Version C Villa Door Stations V2.2.65_231213**Release Note (2023-12-16)**

Firmware Basic Information	Firmware Version	V2.2.65_build231213
	Device Model	DS-KV8X13-WME1(C) DS-KV6113-WPE1(C), DS-KV6113-PE1(C), DS-KV6103-PE1(C) DS-KIS603-P(C), DS-KIS604-P(C), DS-KIS604-S(C)

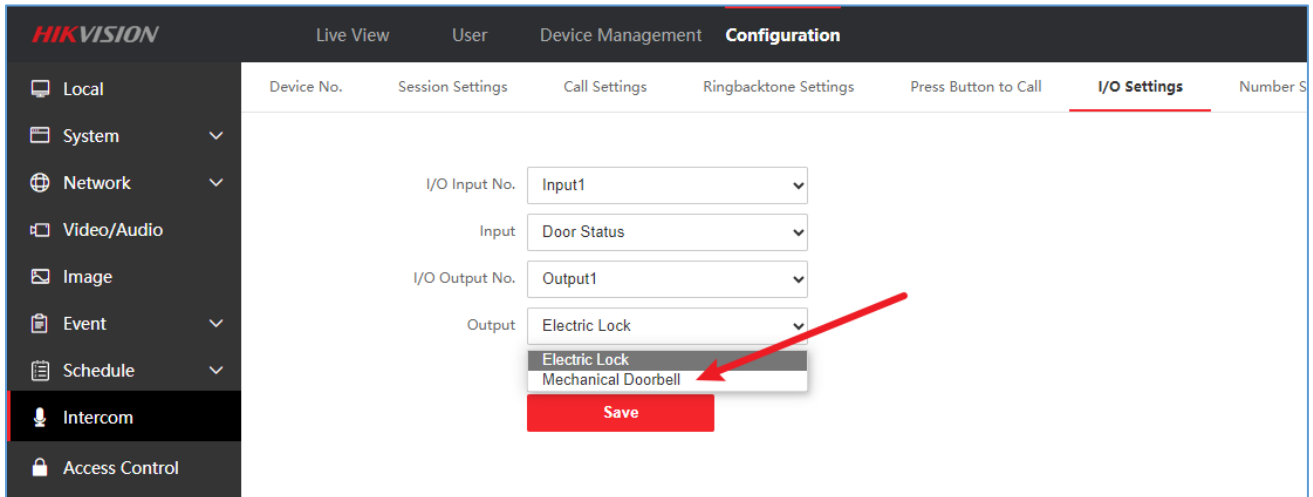
2. Add 13 new languages, now in total support 35 languages. Only two voices "door is open" and "please leave a message" are retained, and the rest of the prompt tones are replaced by Didi, busy tones, etc
